Stage 03: Report to the Authority

GC0068 Grid Code New & Revised Unit Data & Instructions

This proposal seeks to modify the Grid Code to capture changes to unit data and instructions resulting from functionality introduced with National Grid's new Electricity Balancing System.

Electronic Data Communication Facilities

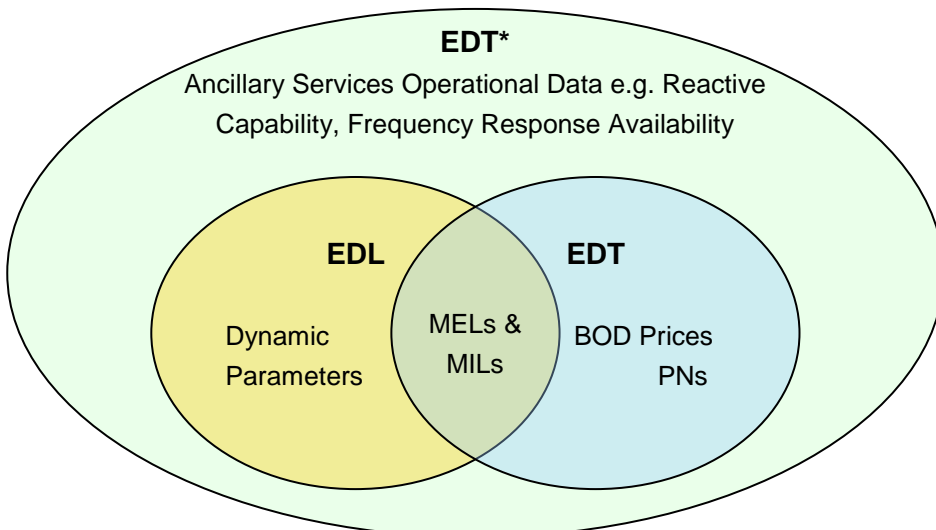
The single replacement for all the Electronic Data Communication Facilities, EDT*, allows the submission of all the data types supported by EDL and EDT plus Ancillary Services Operational Data. EDT* allows data submission over the internet as well as by the existing private networks.

Automatic Logging Device

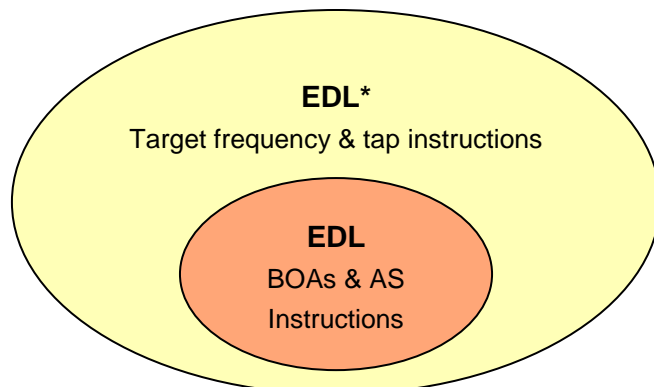
The replacement Automatic Logging Device, EDL*, allows the receipt of all the instructions supported by EDL plus additional Ancillary Service ones.

Figure 1: Default arrangements where BM Unit deviates from zero MZT minutes after deviation to zero

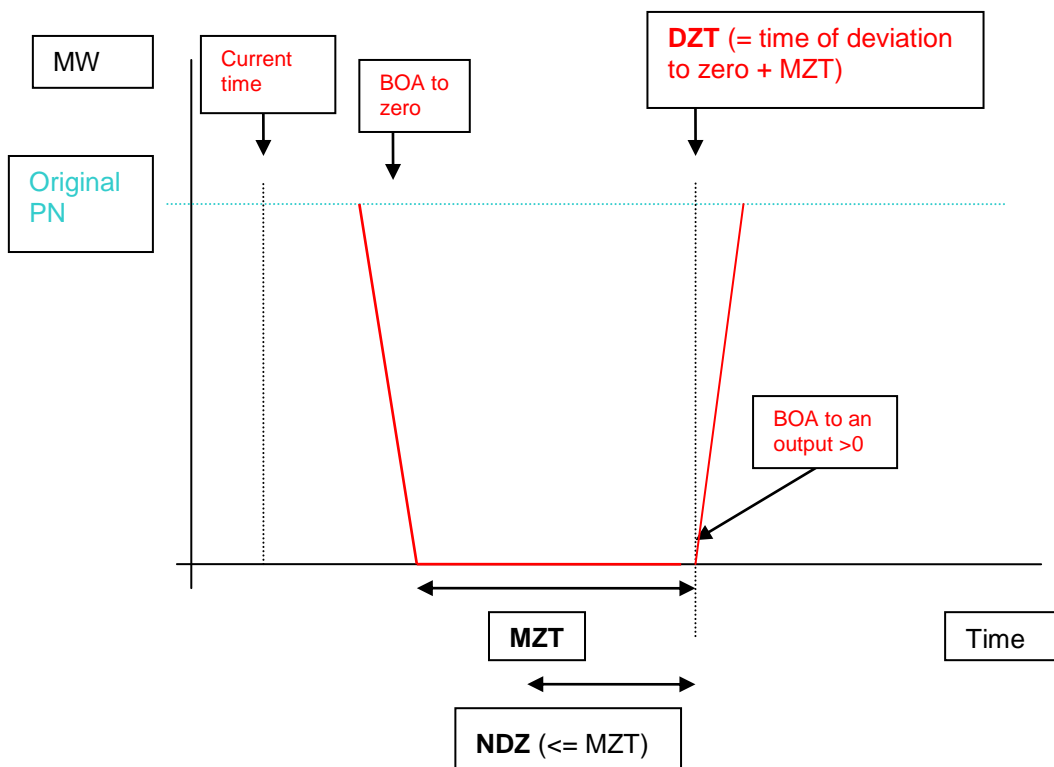
- 3.11 Text has been introduced into BC2 to detail the arrangements that shall apply for the subsequent deviation of a BM Unit from zero following operation at zero as a result of Bid-Offer Acceptances. This is proposed because situations of this type represent a substantial proportion of all re-scheduling activity, but at present the Grid Code does not detail the arrangements that shall apply. To this end a new term Deviation from Zero Time (DZT) has been created to identify the time at which the BM Unit will deviate from zero. This is intended to improve the clarity of this text but is not being introduced as a parameter required for submission. The definition of the Dynamic Parameter Notice to Deviate from Zero in the appendix to BC2 has been revised to now also be applicable when the BM Unit's Physical Notification is non-zero.

- 3.12 First to be outlined are the default arrangements that apply in the absence of any communications between the BM Participant and National Grid. This is illustrated in Figure 1 below. In this specific circumstance, the Notice to Deviate from Zero (NDZ) cannot be greater than the Minimum Zero Time (MZT) as otherwise either the BM Participant would have to be notified of a subsequent deviation from zero before it had commenced operation at zero, or NDZ would effectively over-ride MZT. In this situation, the BM Unit would deviate from zero at MZT minutes after the deviation to zero and National Grid would issue Bid-Offer Acceptances to effect this.

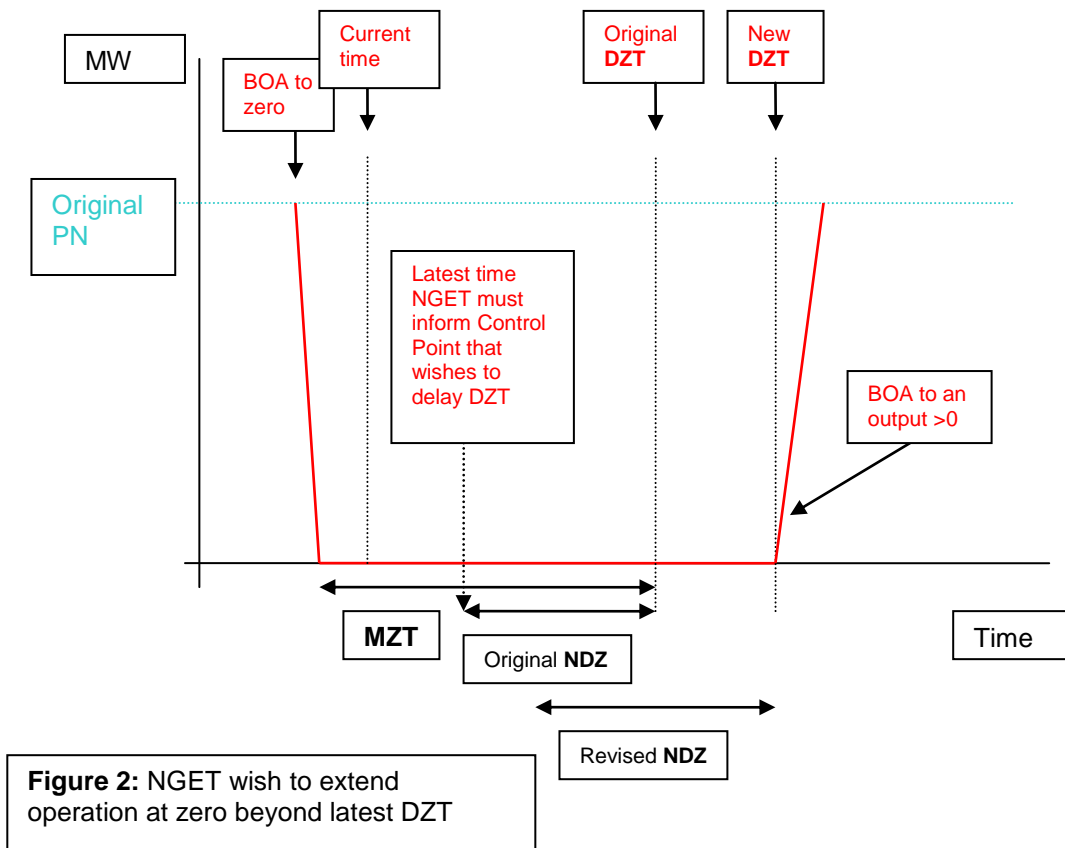
3.13 Secondly, the process by which National Grid would, if required, extend the operation at zero time of a BM Unit beyond the most recently established DZT is outlined. By no later than NDZ minutes prior to the DZT, National Grid would inform the BM Participant that the BM Unit period of operation at zero requires extending by communicating a new DZT. Once notified of this the BM Participant may re-declare the NDZ of the BM Unit such that it is applicable to the revised DZT, but that still allows the new DZT to be achieved. This allows the BM Participant to reflect any increase in NDZ as a result of extended operation at zero, which will be respected if National Grid wish to further extend the operation at zero. This is demonstrated in Figure 2 below.
